Reference: DC/18/01359/FULL1

Site Address: Land Adjacent To 9 Bracken Hill Lane Bromley

Reference: Erection of 2 storey two bedroom dwelling house with associated amenity space, landscaping, car parking and access onto Bracken Hill Lane, with cycle and refuse storage.

**OBJECTION TO PLANNING APPLICATION  
DC/18/01359/FULL**

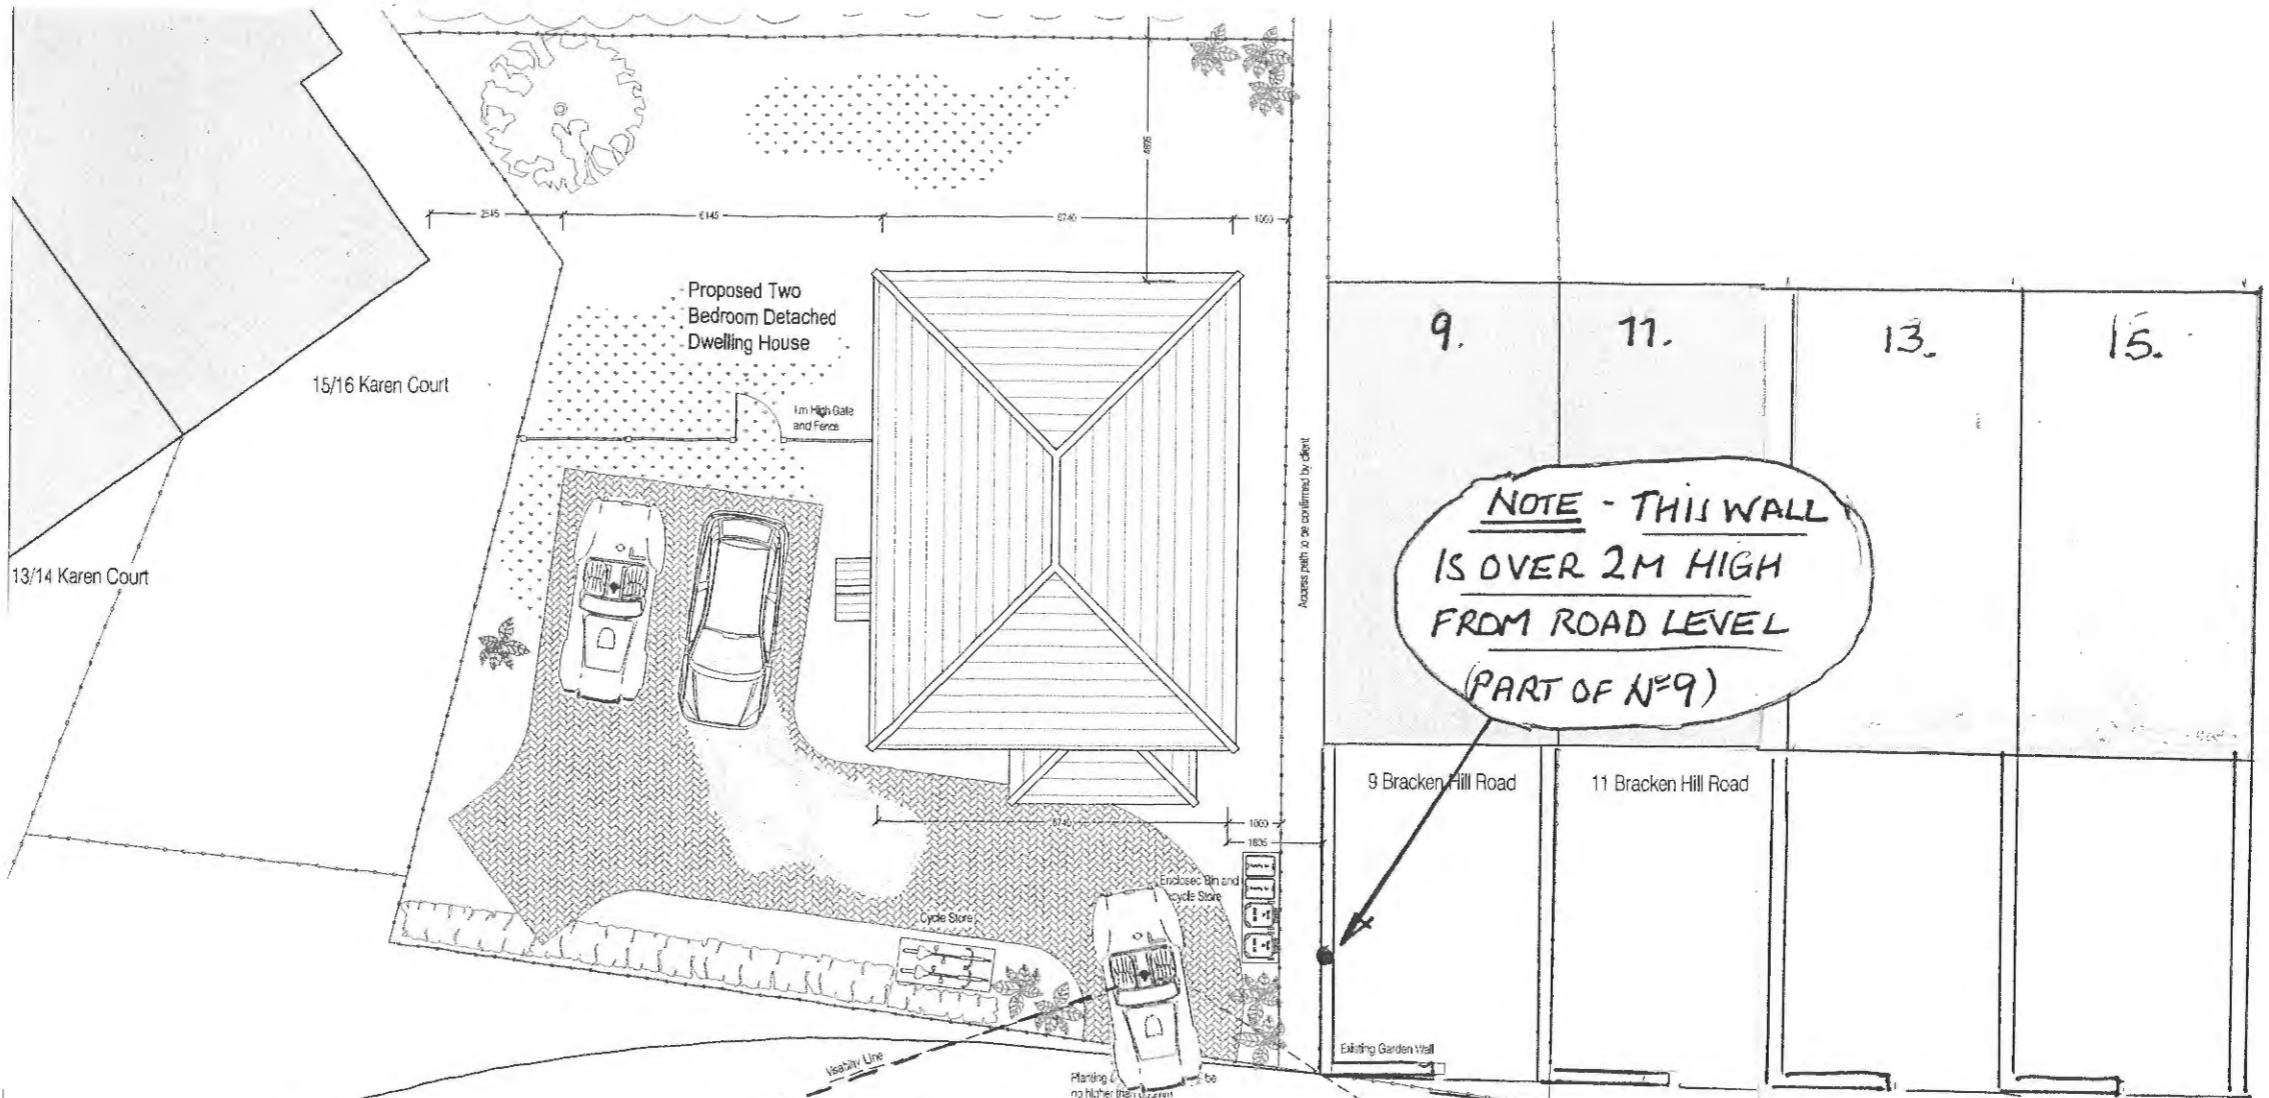
The proposed development shows an over site reduction of the current level of 70.00 by 1 metre, down to 69.08.

I refer you to my drawing BHL/18/002 Rev – dated 23.05.18, copy attached.

There are no indications of

- How the gardens to 13 to 16 Karen Court are retained.
- The effect of excavating, in places, within 2 metres of the existing footings to Karen Court.
- How the gardens to 16 Blyth Road are retained.
- How the current levelled walkway to the rear of No.9 Bracken Hill Lane is managed.

**BHL/18/001 REV -**

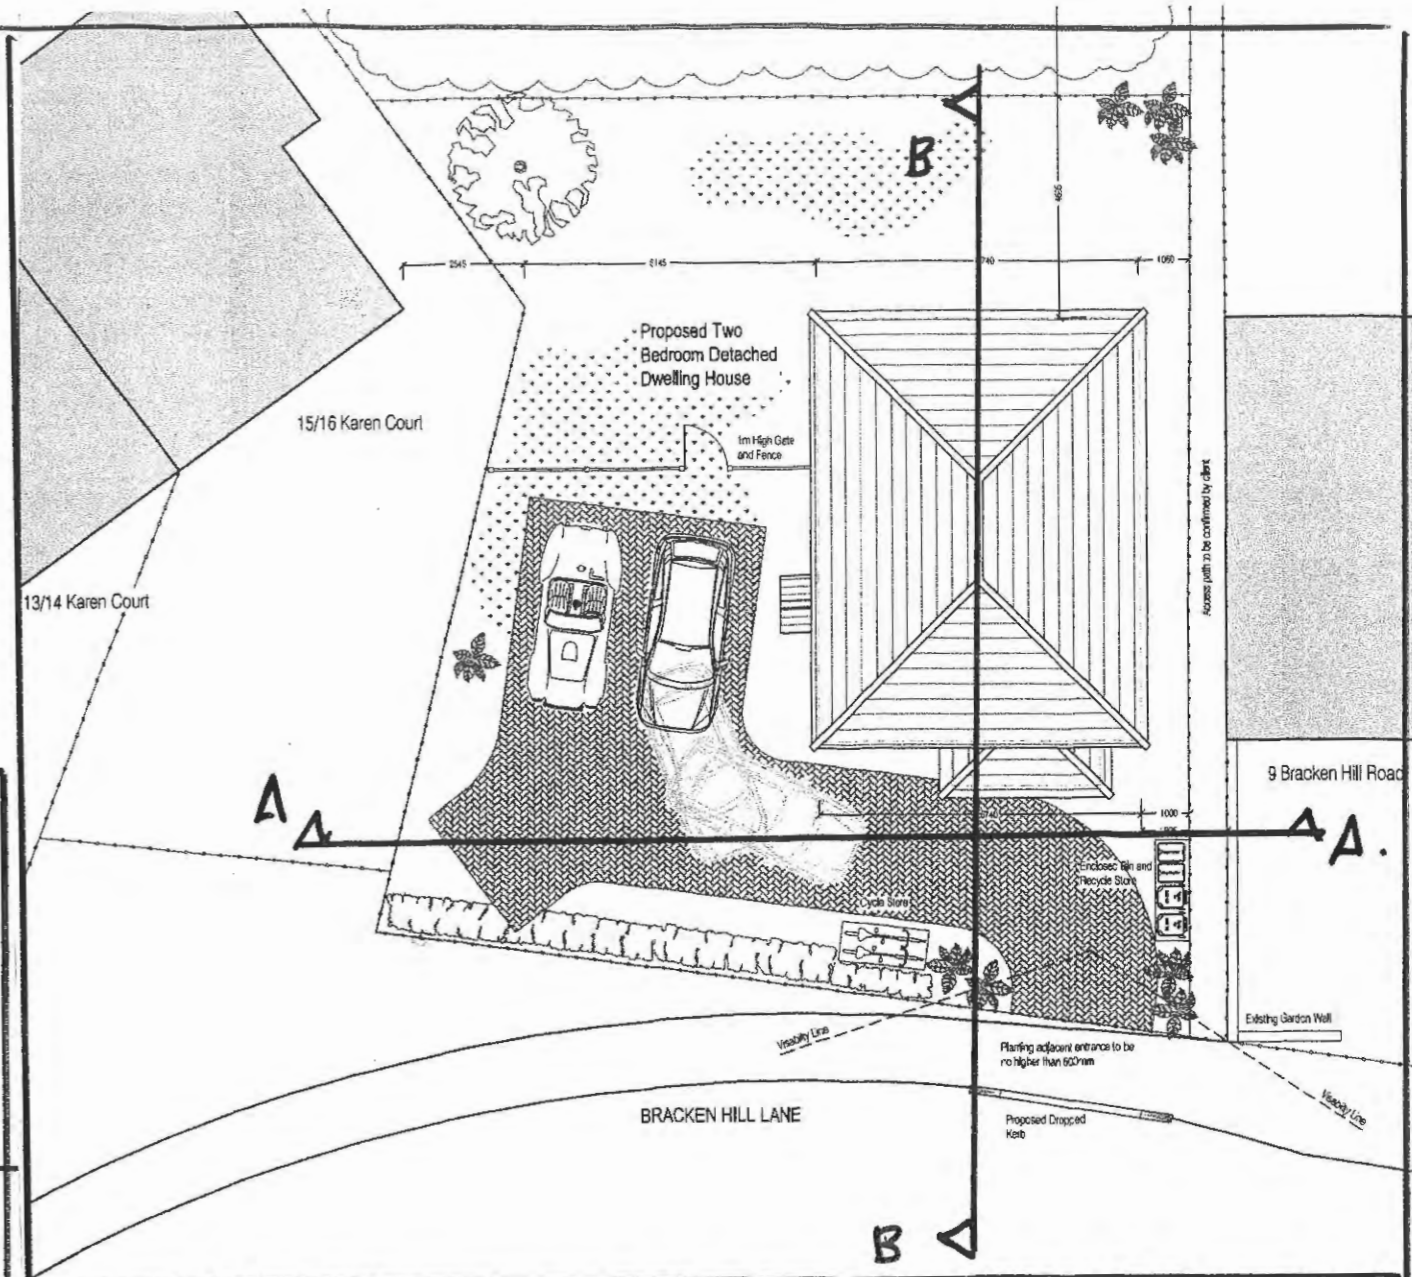
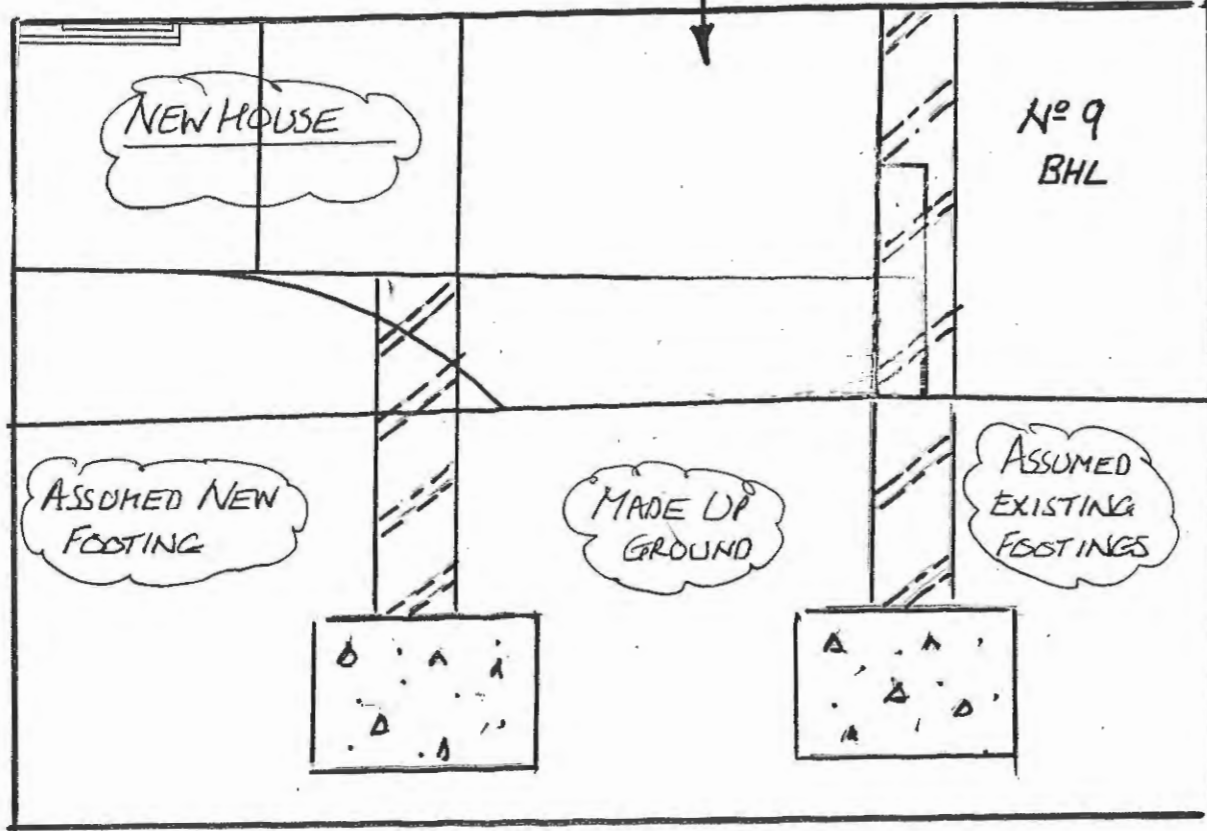
Drawing 3077-17-PL001 rev P4, showing the exit from the proposed site, indicates the potential sight/visibility lines that the design would achieve, without actually demonstrating the dimensional sight lines.

As a vehicle exits from the proposed development, there is a neighbours wall on its' left hand side that is over 2 metres high.

My drawing BHL/18/001 REV, copy attached – dated 23.05.18 demonstrates the potential sight/visibility lines of 17.3 metres that are constrained by the 2 metre high wall.

The recommended sight/visibility line for a 30 mph vehicle is 40 metres as laid out in the Manual for Streets.

**NOTE - THIS WALL IS OVER 2M HIGH FROM ROAD LEVEL (PART OF N<sup>o</sup>9)**

**OVERPRINT TO DRAWING  
3077 - 17 - PL001 P4,  
SHOWING SIGHT /VISIBILT  
LINES OF TRAFFIC AT 30 MPH.**

**BHL/18/002 REV -**

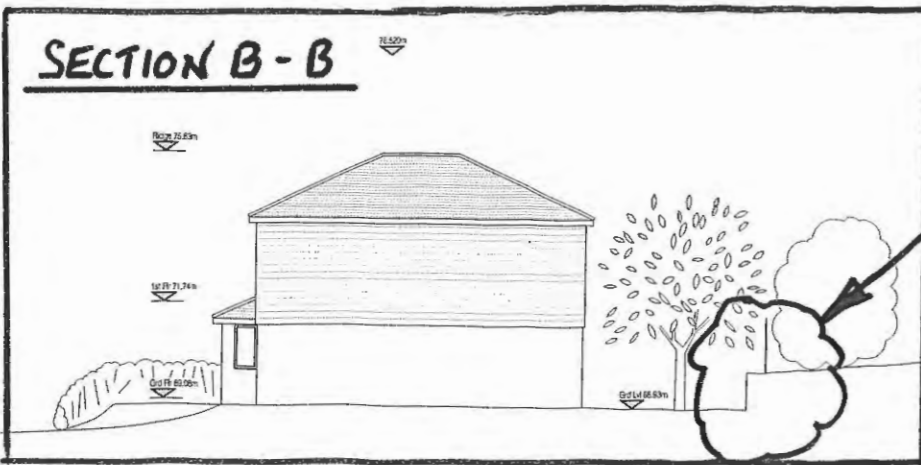
**SECTION A-A**

HOW IS THIS BANK STABILISED ?

**SECTION B-B**

HOW IS THIS BANK STABILISED ?

**OVERPRINT TO DRAWINGS  
3077 - 17 - PL002 P2,  
SHOWING DETAILING REQUIRED  
BEFORE WORKS COMMENCE.**
